## ADDENDUM NO. 1

November 14, 2023

PROJECT: Port Perry Cannabis Facility, 8 Easy Street, Port Perry, ON

4. Please confirm all asphalt for this project is as per the recommendations on drawing SG-1 (Site Grading Plan) (see below for reference)?

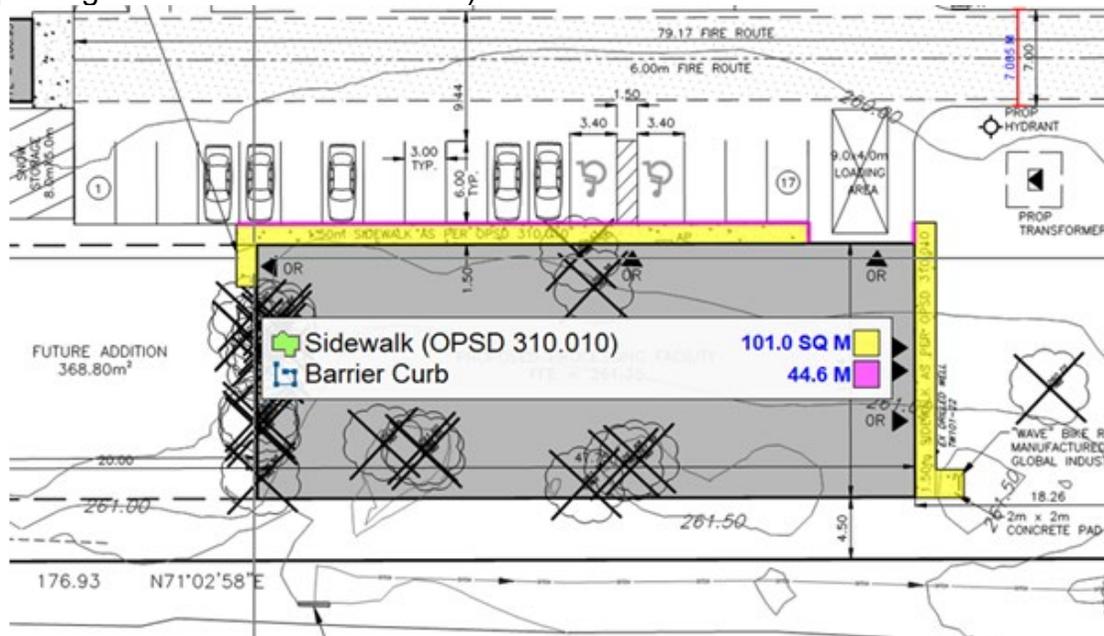
9. DRIVE AISLE SHALL CONSIST OF THE FOLLOWING UNLESS OTHERWISE APPROVED BY THE GEOTECHNICAL ENGINEER:

- 300mm GRANULAR 'B'
- 150mm GRANULAR 'A'
- 50mm HL8 ASPHALT
- 40mm HL3 ASPHALT

*The noted pavement design is the light duty pavement makeup and has been mis labelled as for the drive aisle on the grading plan. Heavy duty pavement shall be made up of 40mm HL3, 90mm HL8 (2 lifts), 150mm granular 'A', and 450mm granular 'B'. Please see the attached geotechnical report for more information. Heavy duty pavement is required beneath the fire route, all other parking areas can be light duty.*

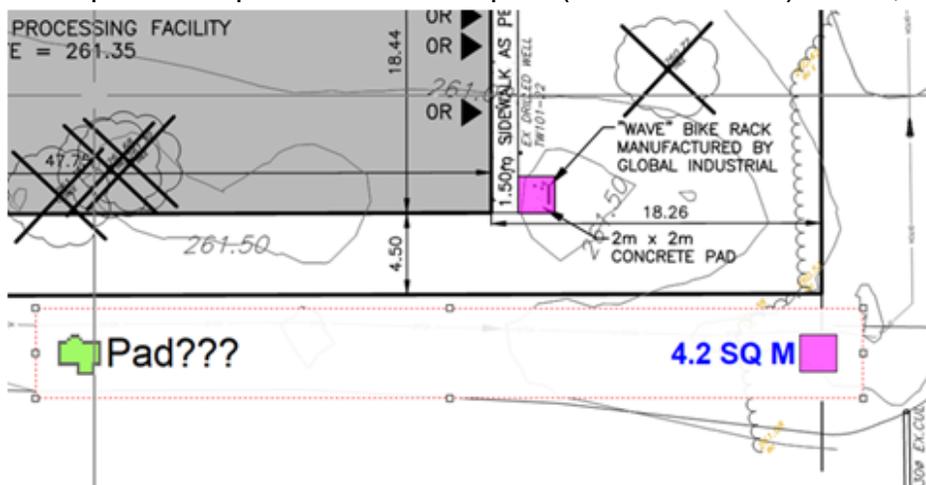
6. Regarding the sidewalk SOW, please confirm if a curb is required along the interface between concrete sidewalk and asphalt paving (see below for reference)? If this is a raised sidewalk we have to include for a curb (but the drawings don't show any top/bottom curb elevations) along the edge of sidewalk where it interfaces with asphalt (even if it's a monolithic pour). If it's not a raised sidewalk than I believe they should be including for parking curbs at all parking spaces along the sidewalk frontage (but no parking curbs are indicated either).

*The sidewalk is not raised, it is to be flush with the asphalted driving surface. Parking curbs should be included along the spaces that abut the sidewalk. 14 x 8" long parking curbs will be required in total.*

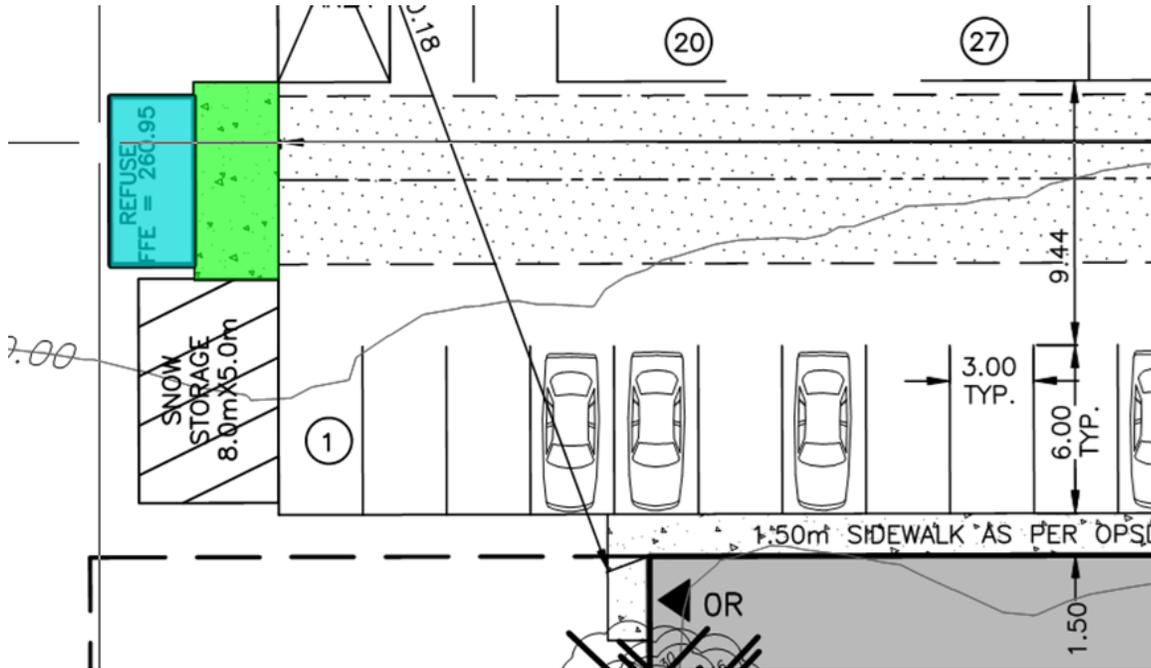
7. Confirm the bike pad (see below pic) is just an extension of the concrete sidewalk and we are to price it as per the sidewalk spec. (OPSD 310.010)? If not, clarify?

*Correct, the bike pad is to be an extension of the concrete sidewalk.*

### DETAIL 1 – SINGLE LINE DIAGRAM

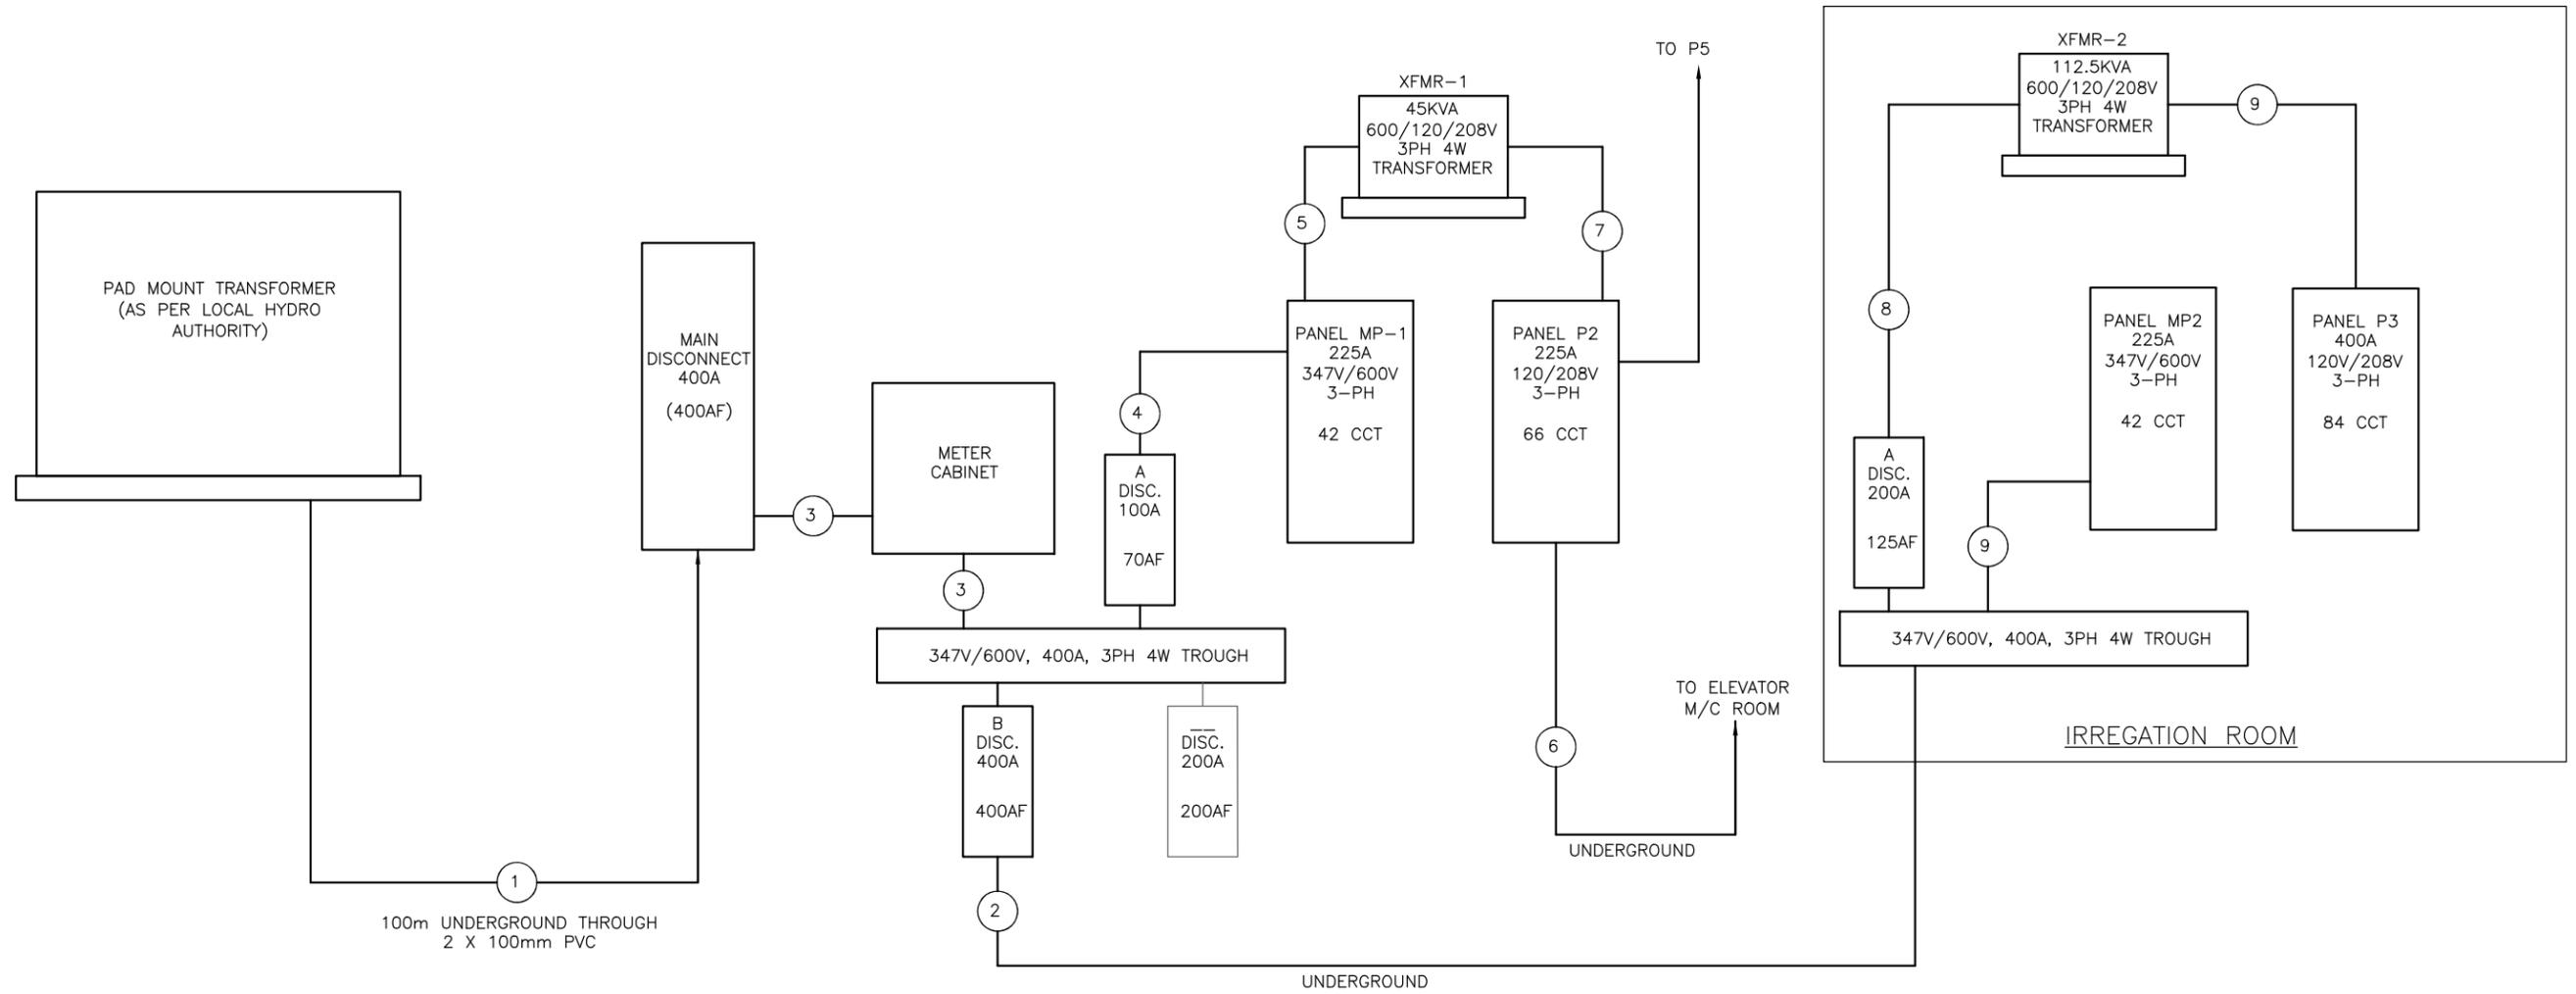
10. RTU information is all shown on drawing M1, equipment list. No building control system is to be included at this time.
11. The electrical site plan is not available at this time. Further information to follow.
12. Circled notes/wire sizes; please see attached revised single line drawing.
13. 3-wire trough corrected to 4-wire, as per attached.
14. Transformer and feeds adjusted from 75kVA to 112.5 kVA as per attached.

15. In addition to above two items and electrical layout, the new schematic attached has removed the 90A 3-pole breaker from panel MP1 as well as second underground feed to irrigation room. New layout has a single underground feed to irrigation room, new 400A 4-wire trough, and new 200A disconnect with 125A fuse for transformer XFMR-2.
